PLANNING COMMISSION MEETING AGENDA REGULAR MEETING

SPECIAL USE APPROVAL AND PRELIMINARY SITE PLAN REVIEW (SU JPLN2024-0021) – Proposed Residence Inn Hotel, South side of Butterfield, East of Coolidge (2125 & 2155 Butterfield), Section 29, Currently zoned BB (Big Beaver) Zoning District.

DATE: November 21, 2024

Special Use and Preliminary Site Plan For City of Troy, Michigan

SHEET + TITLE PHOTOMETRIC LIGHTING PLAN

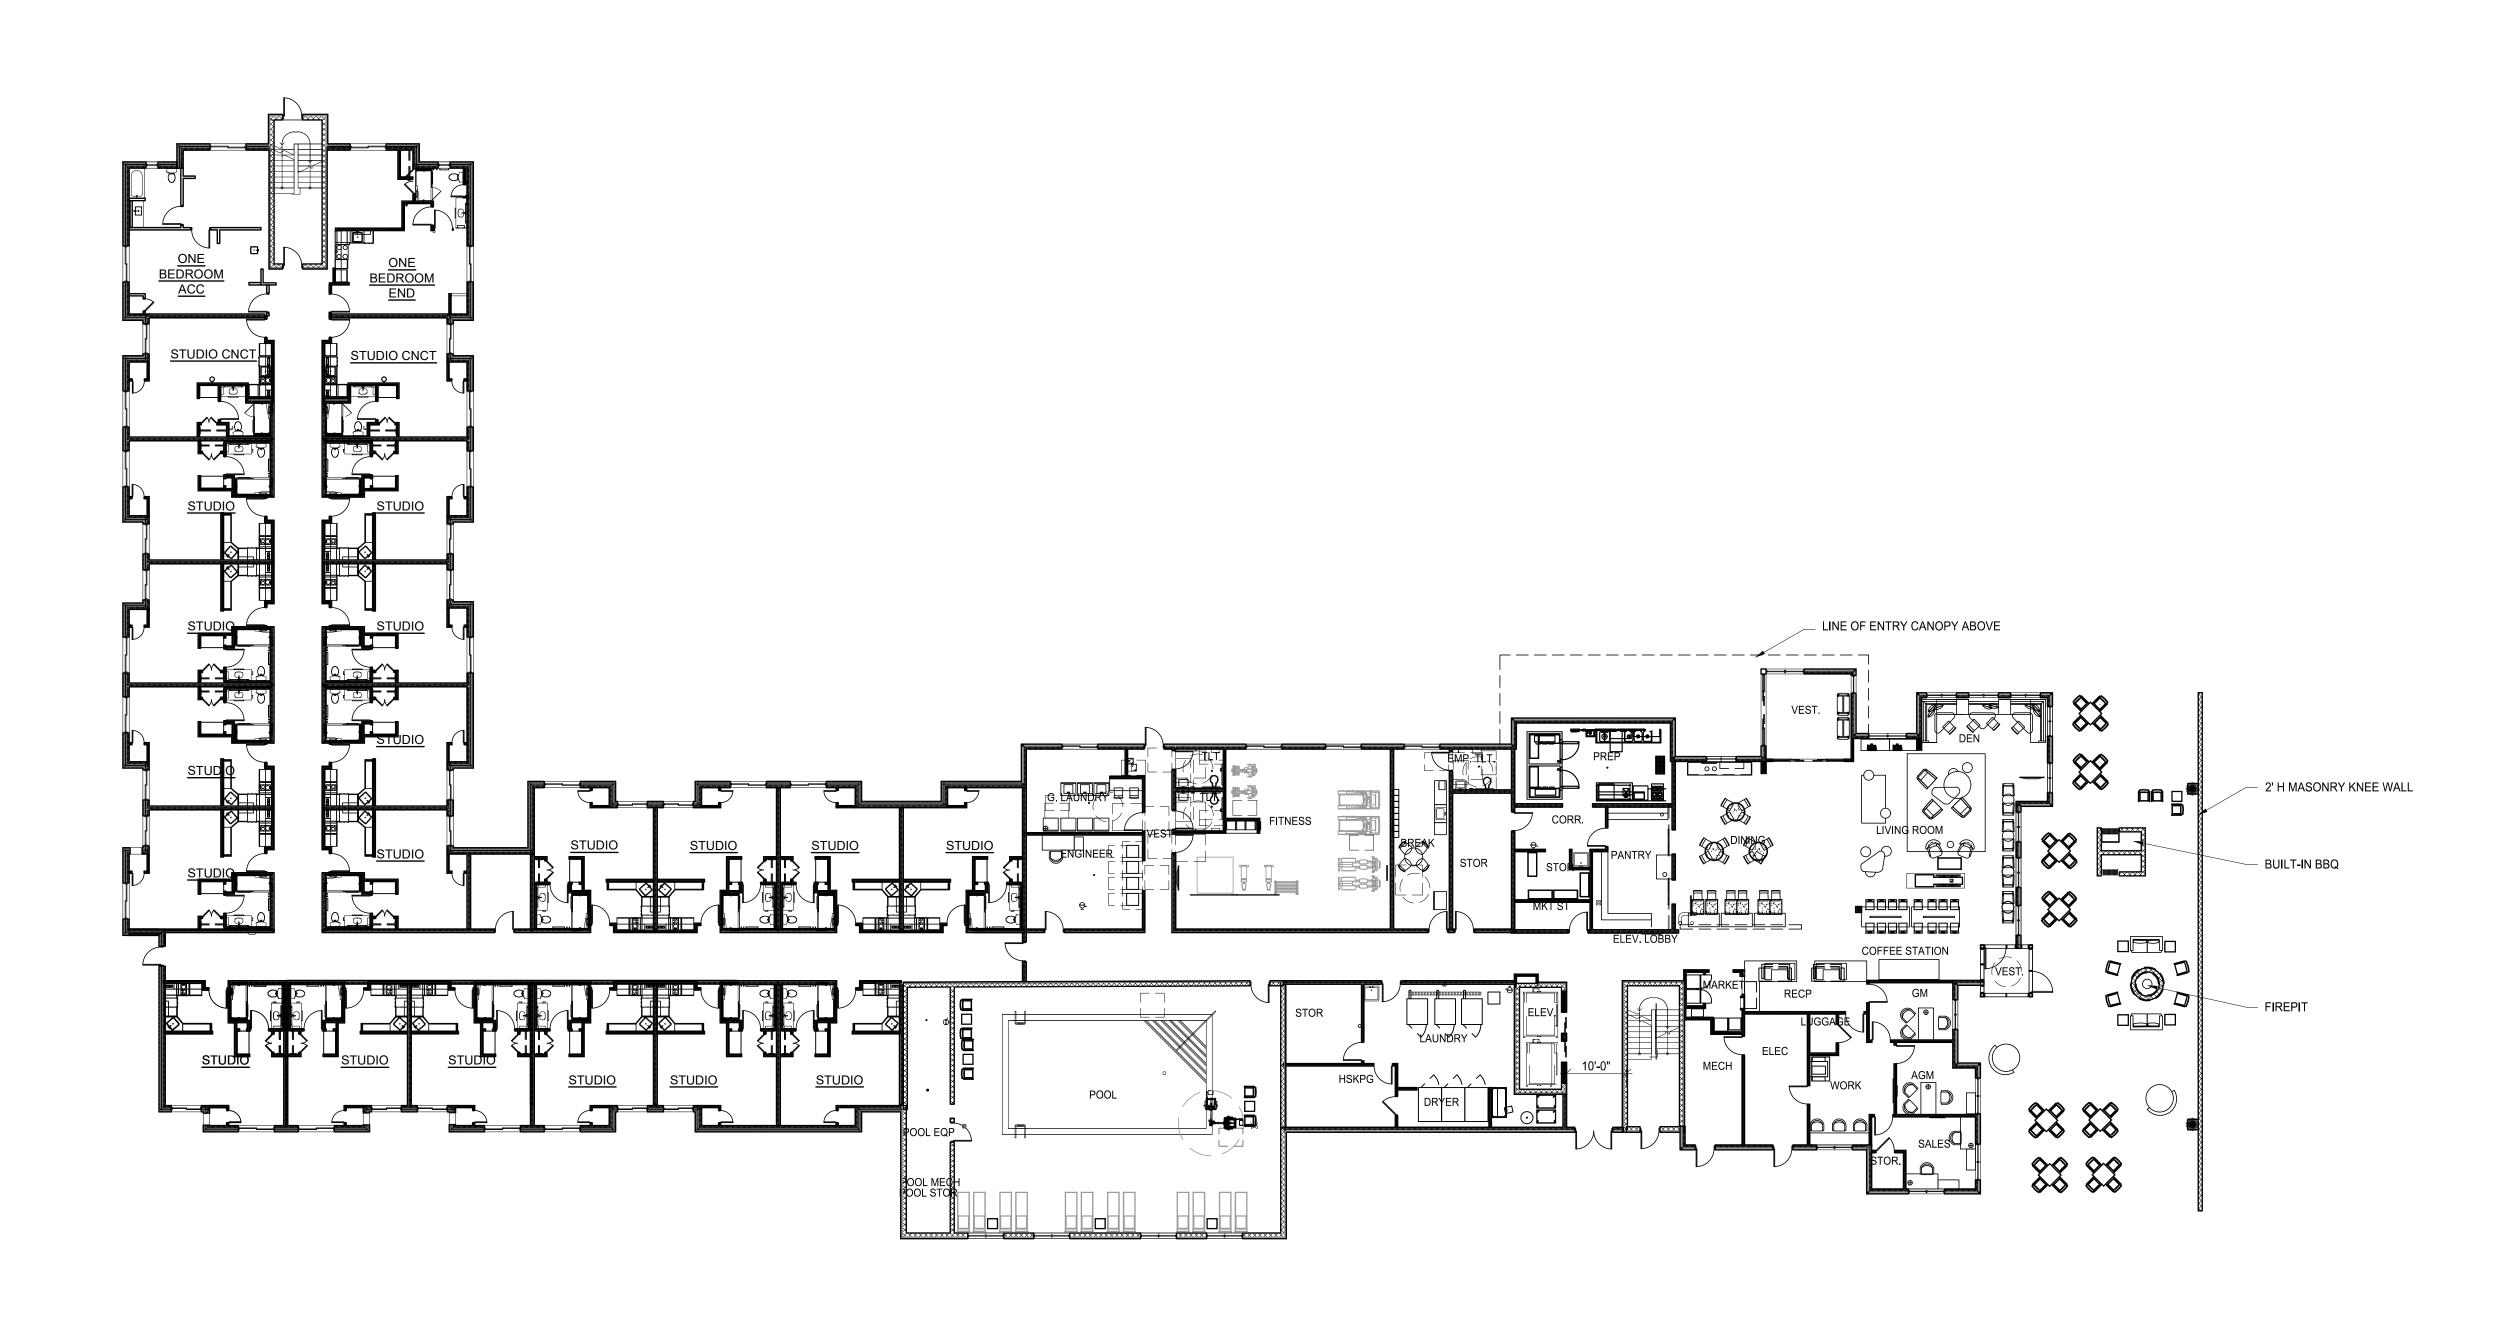
Photometric plans have been provided, including the subject site and the shared parking area on the site to the west. Twelve (12) wall-mounted lights are shown along the building and three (3) pole lights are shown in the parking area. All light fixtures are at compliant height. Lighting levels along the lot lines to the north, south, and east are compliant. Lighting levels along the west lot line exceed one (1) foot-candle where the shared parking area crosses property lines. This is acceptable as sufficient lighting is needed within the parking lot, and such lighting does not negatively impact any neighbors.

SHEET + NUMBER
A-300

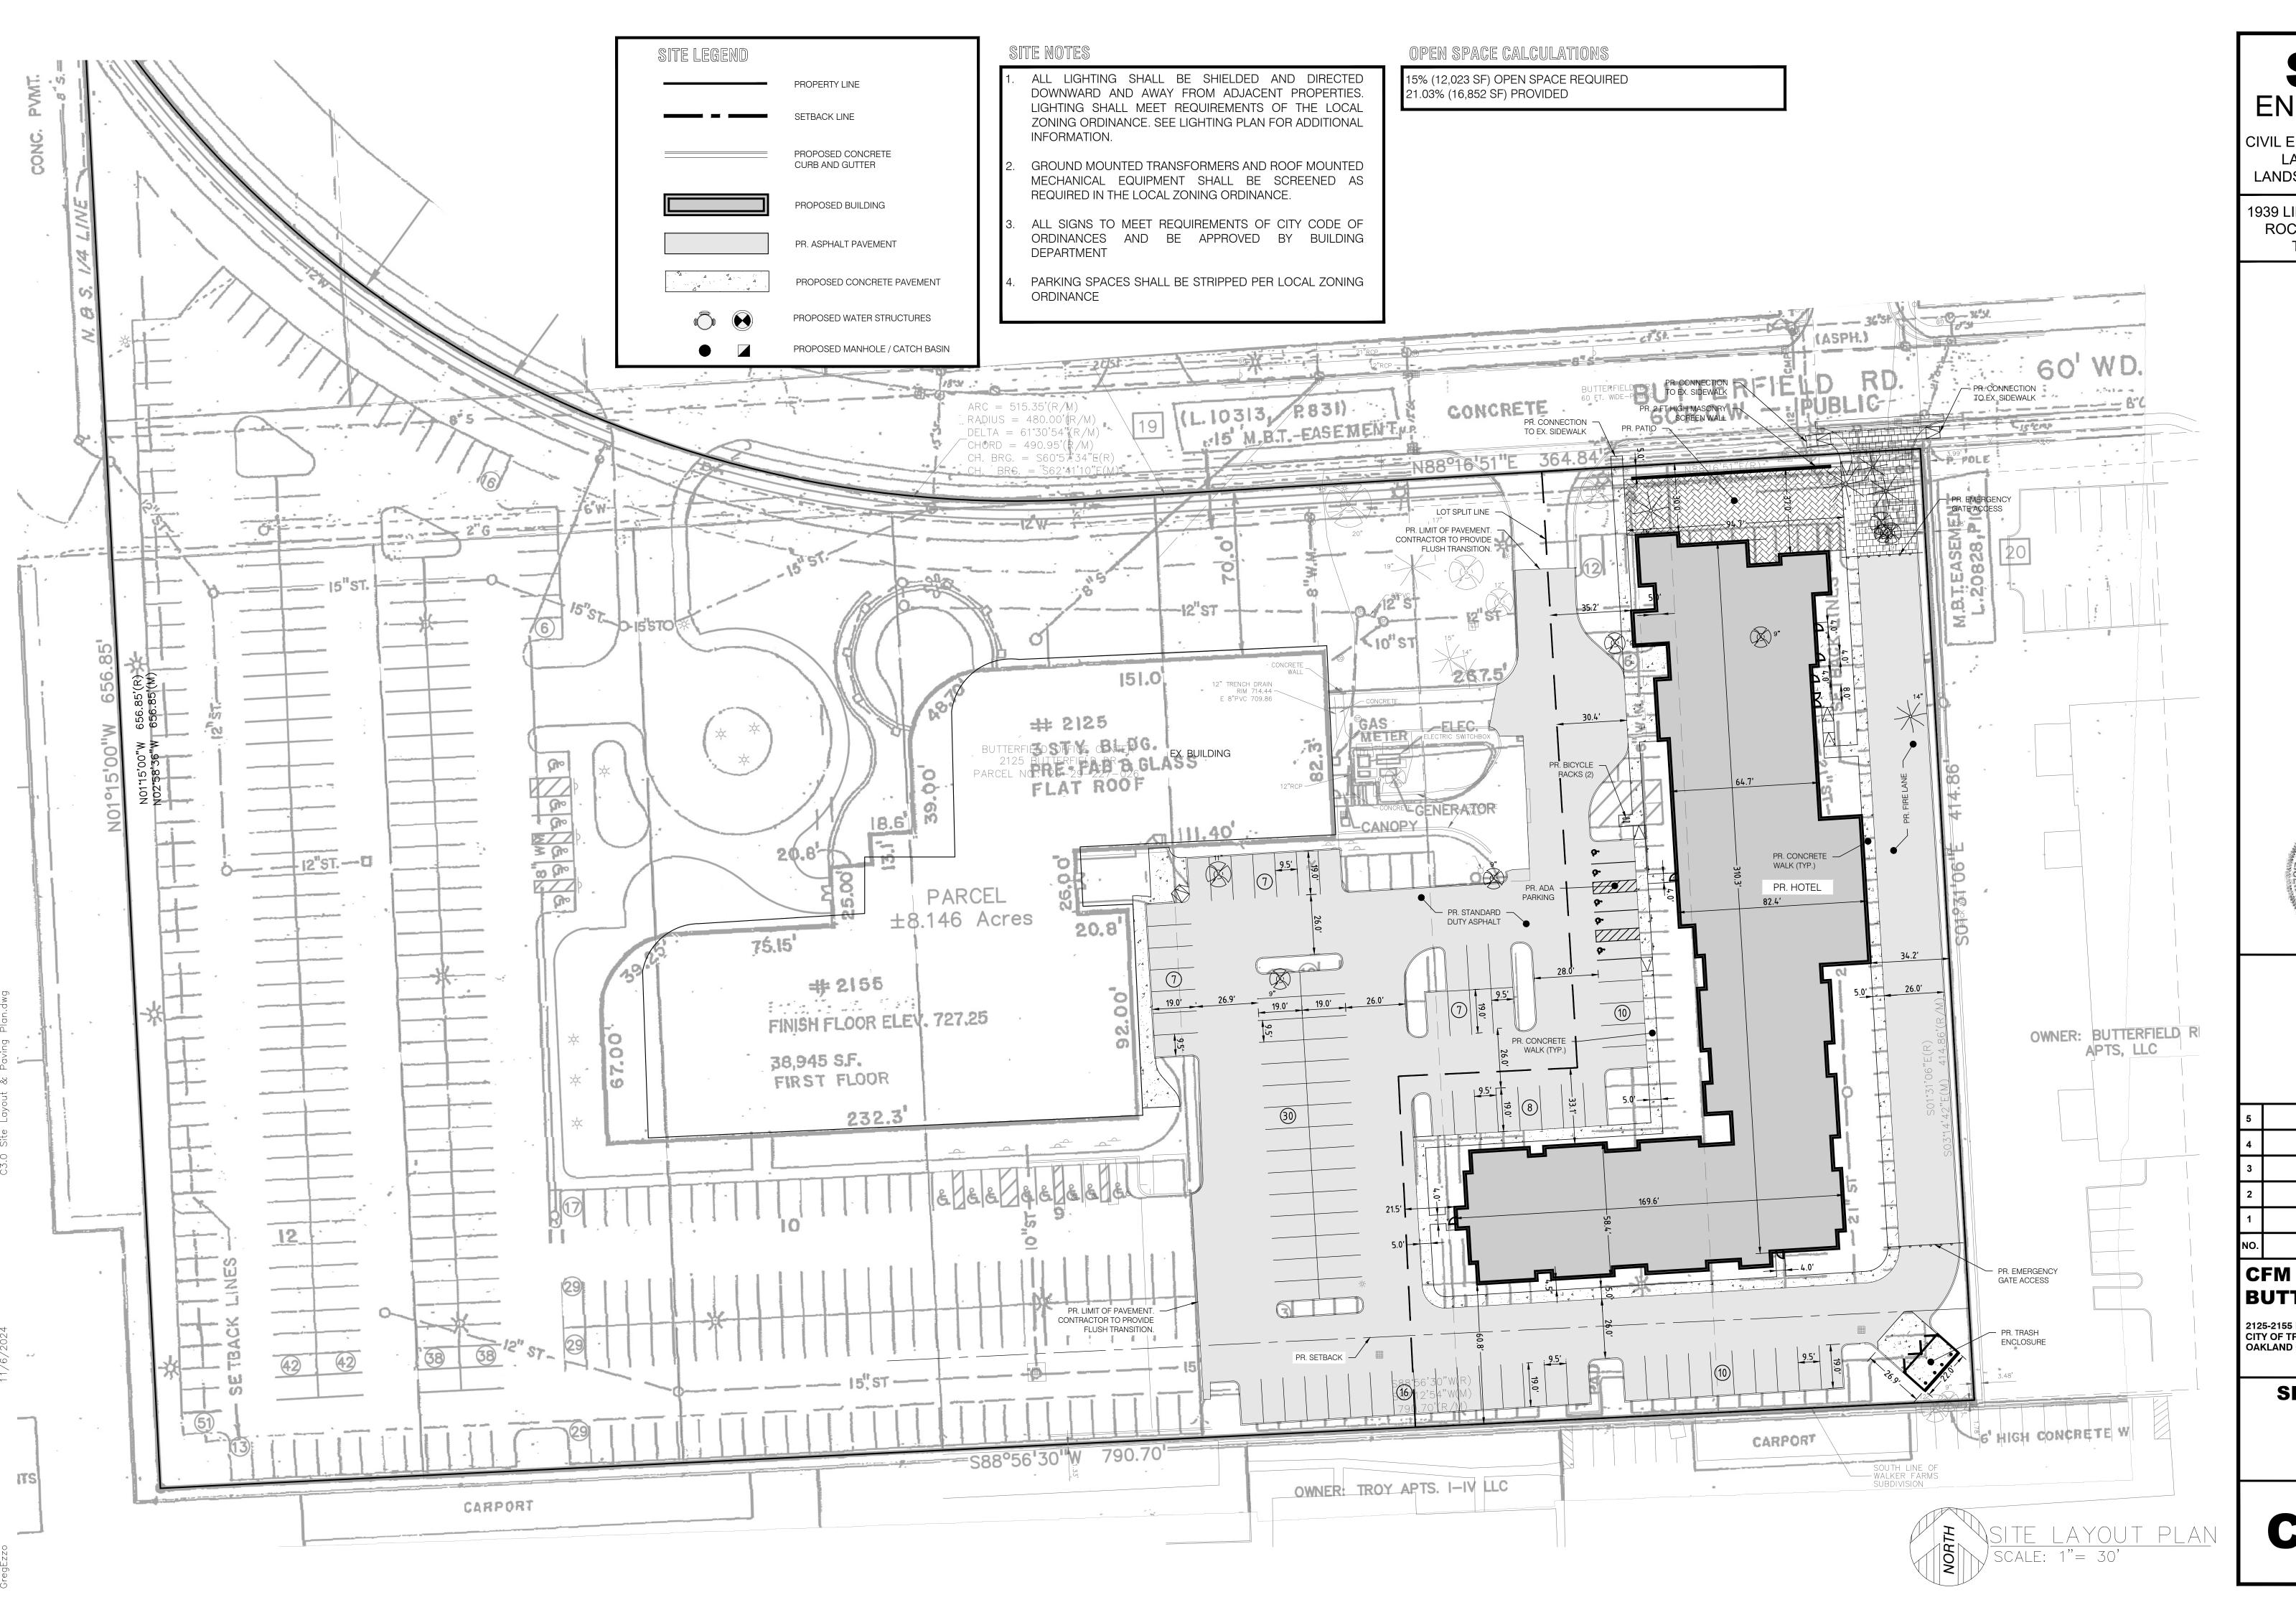
The proposed hotel is located in and around other apartment and office buildings. In previous site plan reviews and resubmittal meetings with the applicant, we had requested that the proposed elevations match a development style and the quality of adjacent properties, such as Regents of Troy, rather than typical Residence Inn hotel elevations.

In response to our requests, the applicant has since replaced eifs with brick and expanded the front patio, but the overall look of the exterior remains the same. We still encourage the applicant to revise the proposed elevations and materials to match the quality of adjacent properties, and make the hotel look more consistent of surrounding properties rather than a standard hotel.

Items to be Addressed: 1). Planning Commission to consider whether the proposed design is consistent with architectural design standards of the Big Beaver form-based district.

> **LANDSCAPE PLAN**

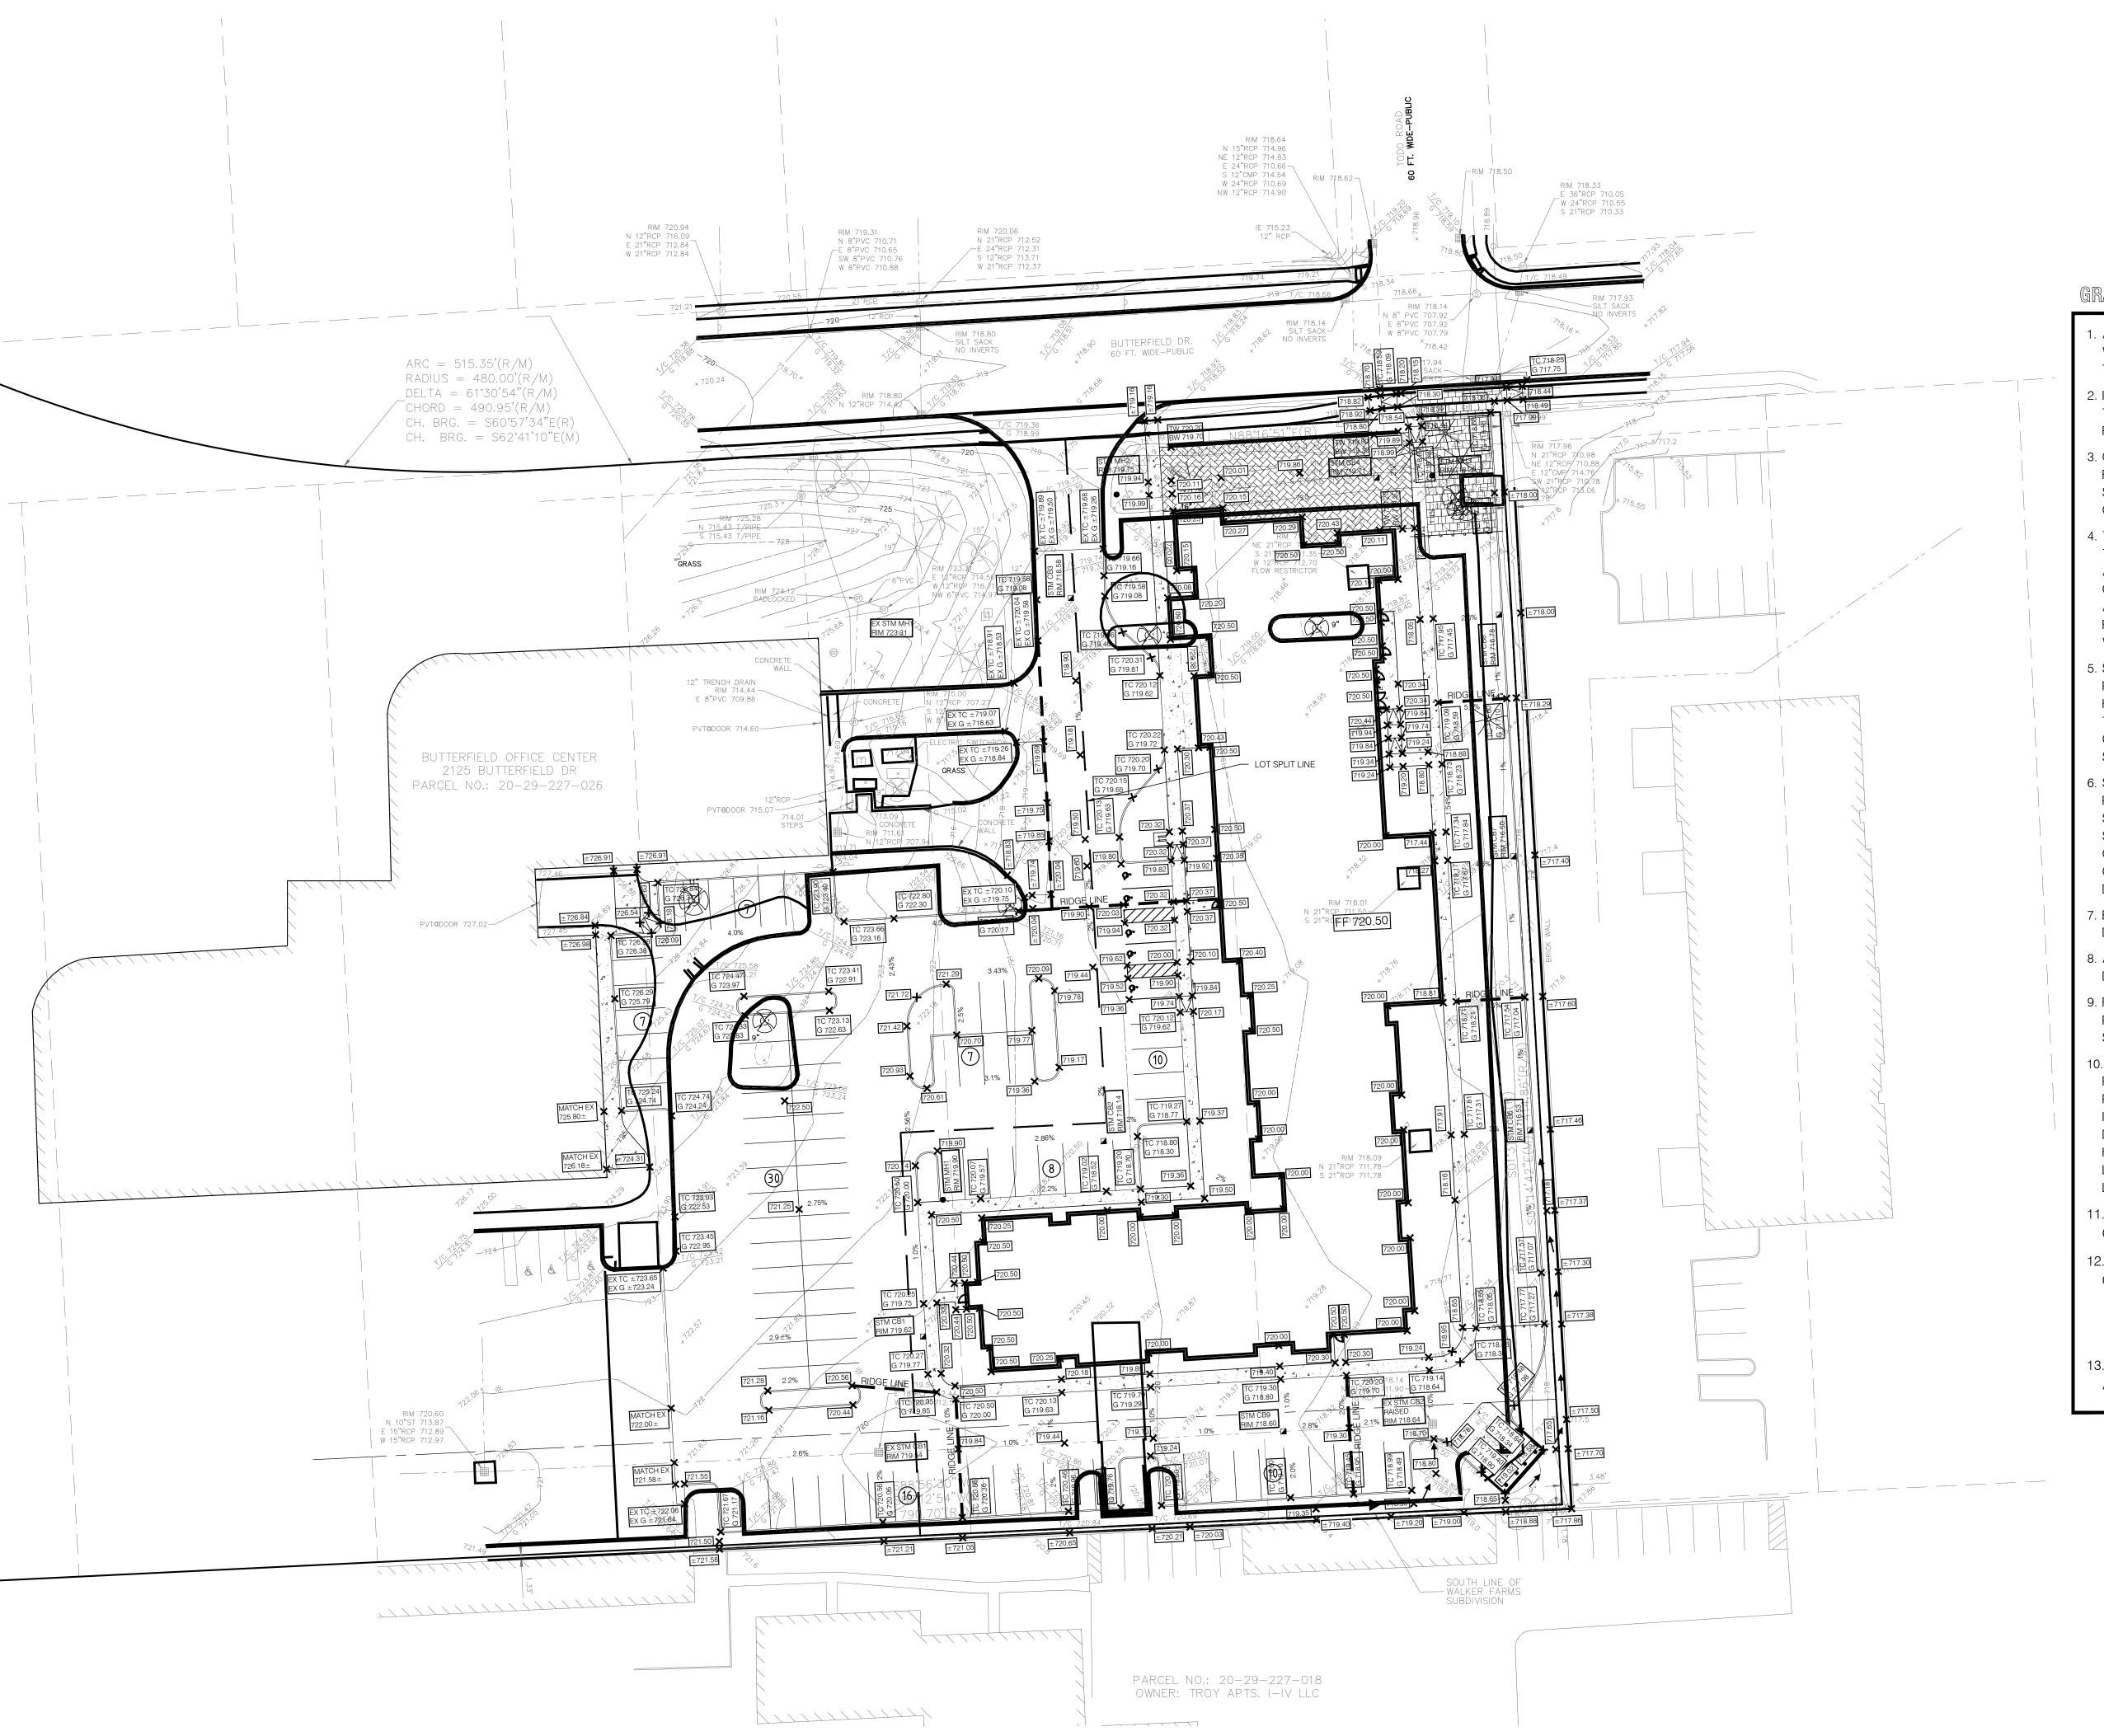
A landscape plan has been provided on Sheet C3.2. The following table discusses the development's compliance with the landscape requirements set forth in Section 13.02.

Section 13.02 requires all landscape plans to be prepared and stamped by a licensed landscape architect. In a memo dated September 11, 2024, the applicant stated that a stamped landscape plan will be provided "at a later date." We emphasize that the professional seal of a landscape architect is a required component of a site plan application and preliminary site plan approval.

Items to be Addressed: 1). Landscape plan and tree inventory shall be stamped by a licensed Landscape Architect.
